Errata for 2021 Uniform Plumbing Code – 2nd Printing

Appendix I – IAPMO IS 31

FIGURE 3
PRESSURE LOSS OF PEX TUBING AT 16 °C (60°F)
(See Section 10.6.2)

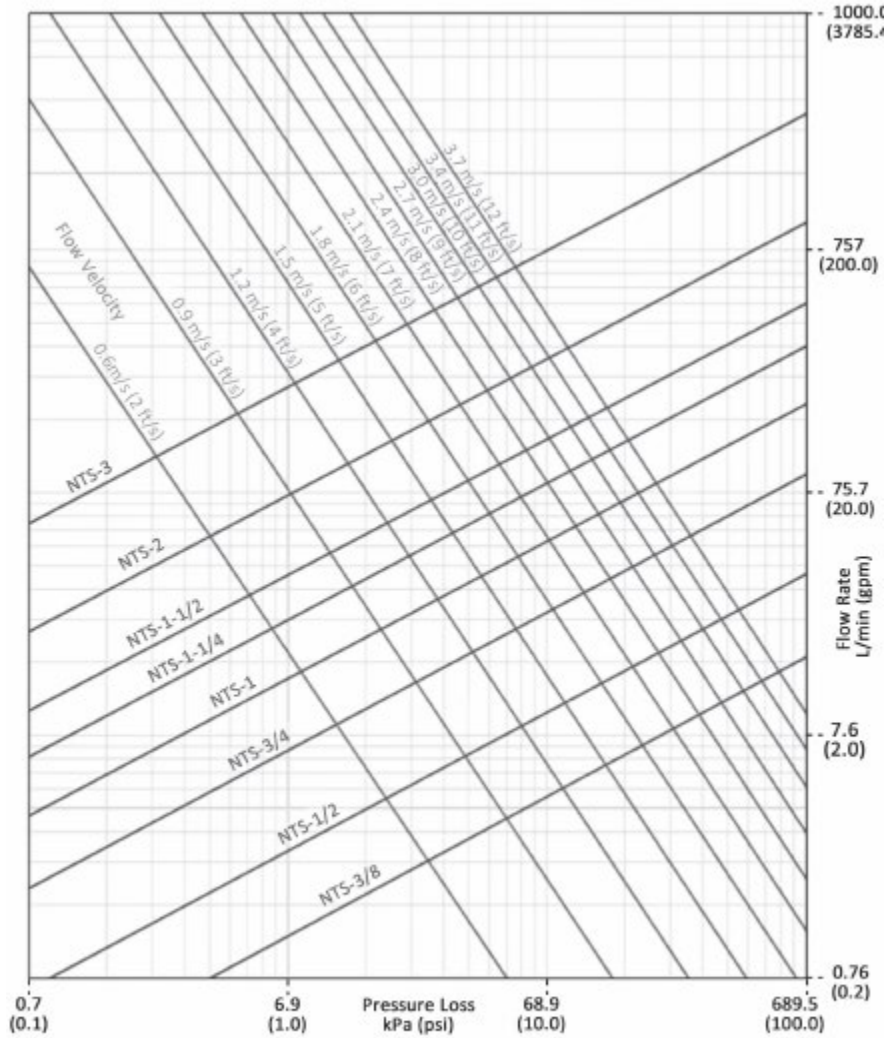
Figure 3 – Revise the conversion under 689.5 at the bottom of the figure, from “(10.0)” to “(100.0)”.

FIGURE 4
PRESSURE LOSS OF PEX TUBING AT 49 °C (120°F)
 (See Section 10.6.2)

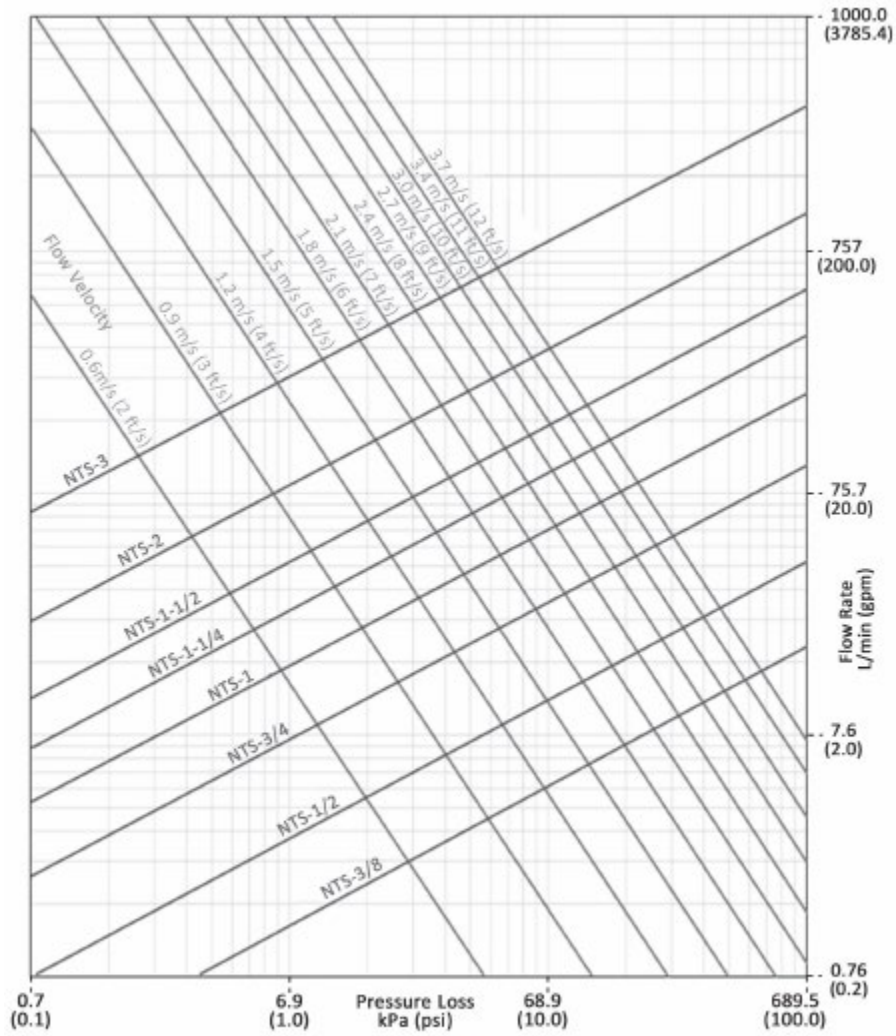
Figure 4 – Revise the conversion under 689.5 at the bottom of the figure, from “(10.0)” to “(100.0)”.
